# TRI-STATE ENGINEERS AND LAND SURVEYORS, INC.

RE: Land Development Plan Review  
Galloway & Richlieu Road  
TMP # 02-046-001  
Bensalem Township, Bucks County, PA  
Project No. BTSO.10001

The following is a point-by-point response (shown in **Bold**) to TPD's review letter dated January 11, 2024.

GRAVITY RETAINING WALL -- TYPICAL CROSS SECTION  
NOT TO SCALE

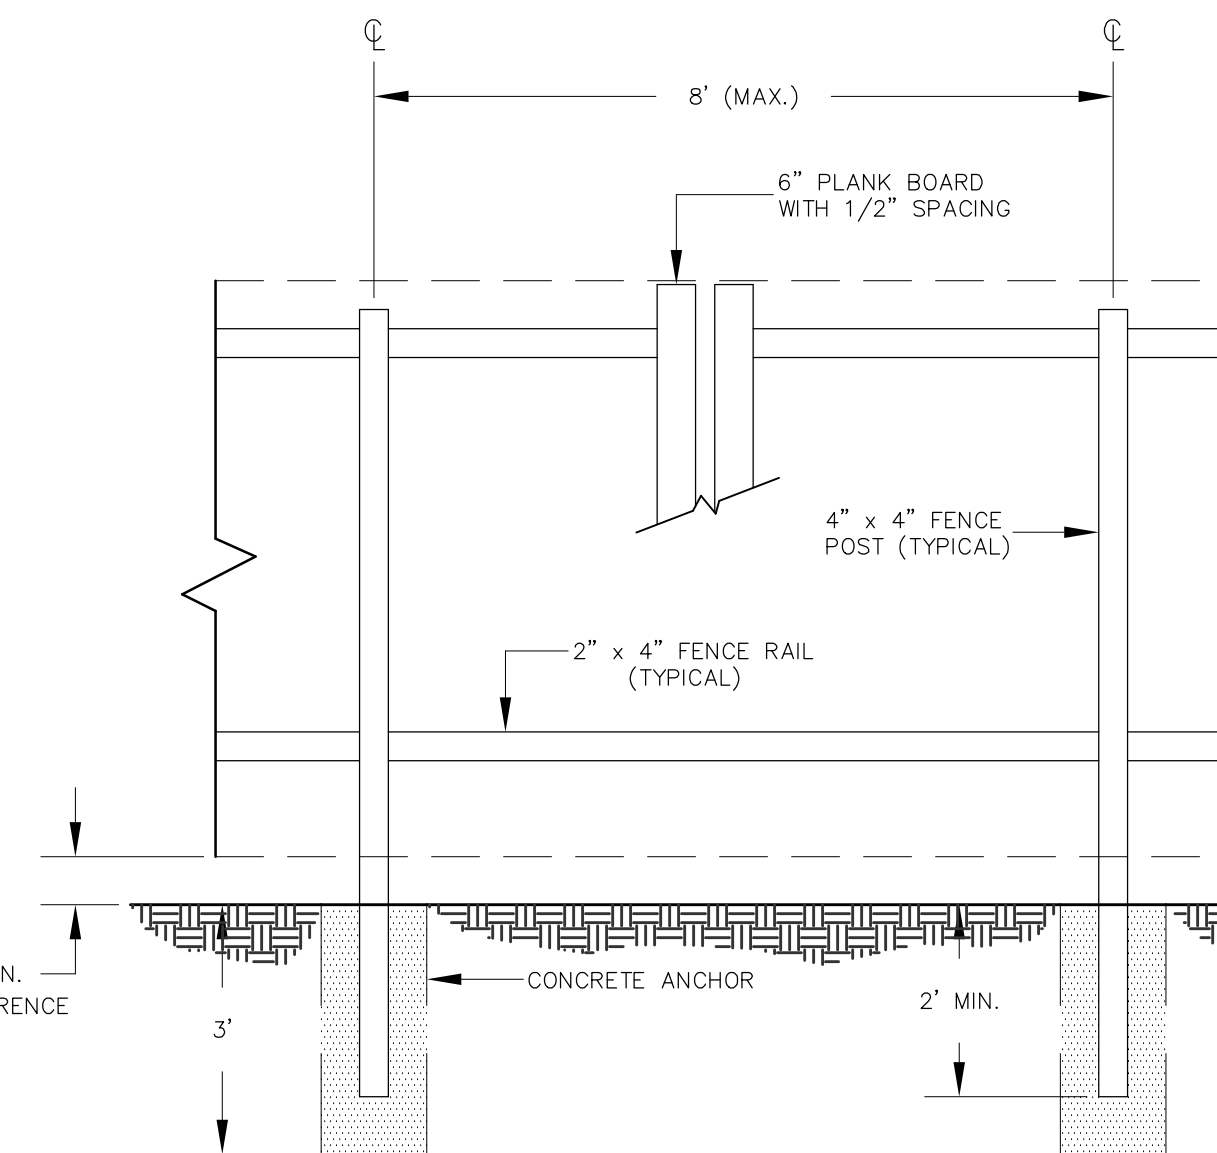
- d. The top of such retaining wall shall be four inches above the finished grade line. The detail shows a matching grade. The applicant shall adjust the retaining wall.

***Response: The top of wall and detail has been revised to show the top of wall being a minimum of four (4) inches above finished grade***

FIGURE 12  
 BUILD SATURDAY MIDDAY PEAK HOUR TRAFFIC VOLUMES

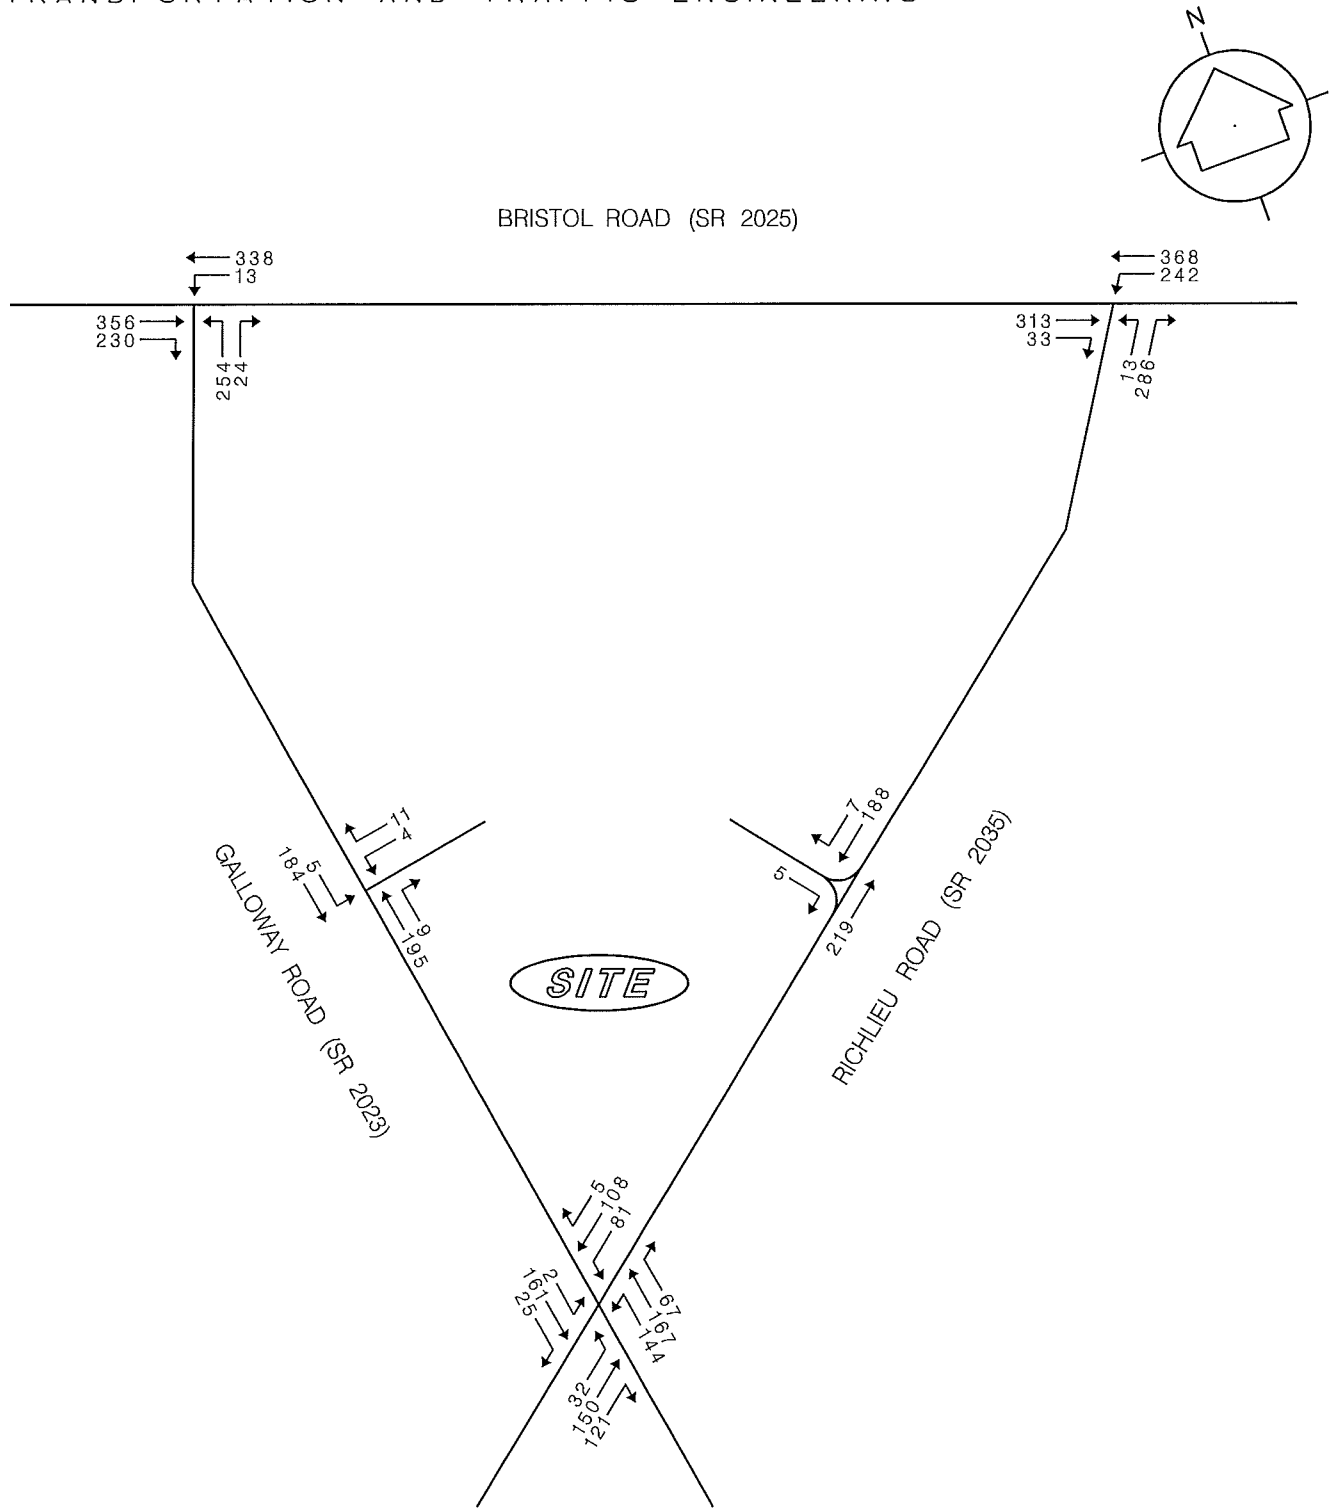
2. a. The HCS files have been provided.
- b. Updated traffic count data sheets are provided in Appendix B of the updated traffic study.
- c. The intersection of Richlieu Road/Galloway Road (AM, PM and SAT) and Bristol Road/Richlieu Road (PM only) have been recounted in late March 2024 on days unaffected by school closures.
- d. Figure 12 has been revised to correct the entering site volumes.
